## ORIGINATION FORM

### Proposed Revisions to a Standard Plans Index

Index Number: 455-440

Index Title: Precast Concrete Sheet Pile Wall (CFRP/GFRP &amp; HSSS/GFRP)

**SECTION THRU BULKHEAD**  
 (Showing Plastic Filter Fabric)

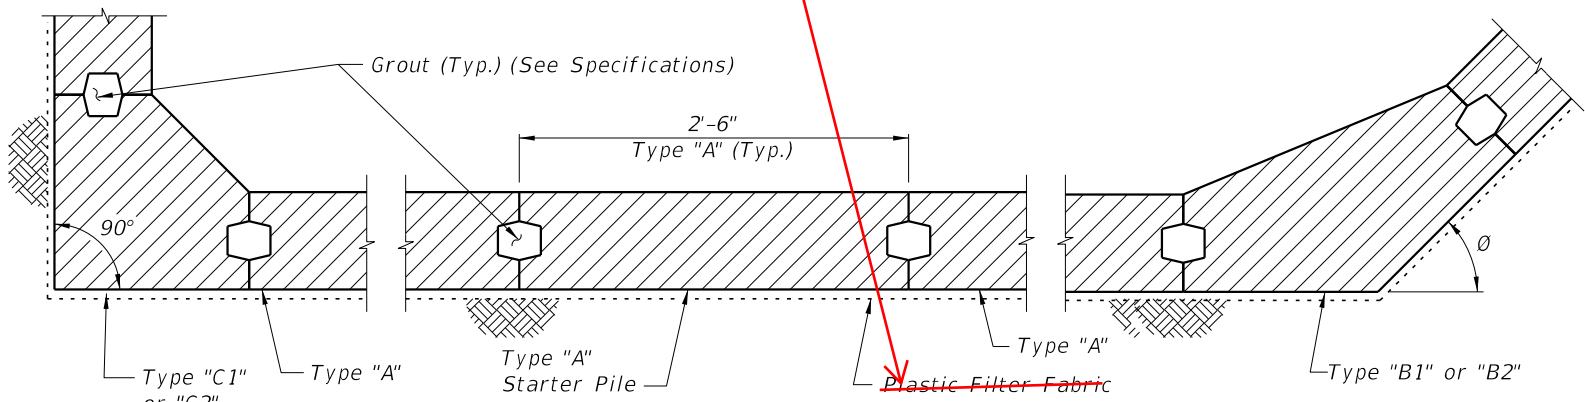
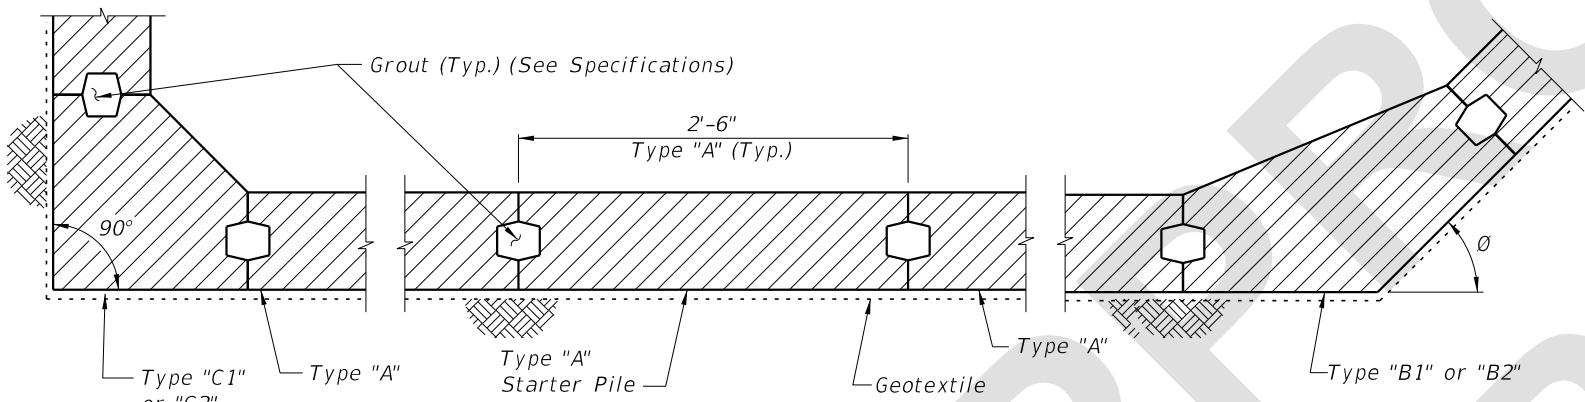
Sheet 1: Changed the "PLASTIC FILTER FRABRIC" Note in the SHEET PILE DESIGN CRITERIA AND NOTES to "GEOTEXTILE: Provide and install Type D-2 or D-3 geotextile in accordance with Specifications 514. Extend the geotextile to the bottom of the "X" dimension."; Changed all references of "Filter Fabric" or "Plastic Filter Fabric" to "Geotextile".

~~PLASTIC FILTER FABRIC:~~  
~~The plastic filter fabric shall extend to the bottom of the "X" dimension.~~

**CHANGE: Geotextile**

Plastic Filter Fabric (Continuous)

Bottom of Dim. X and Filter Fabric

**CHANGED:**  
 Provide and install Type D-2 or D-3 geotextile in accordance with Specification 514. Extend the geotextile to the bottom of the "X" dimension.

**GEOTEXTILE:**  
 Provide and install Type D-2 or D-3 geotextile in accordance with Specification 514. Extend the geotextile to the bottom of the "X" dimension.

**SECTION THRU BULKHEAD**  
 (Showing Geotextile)
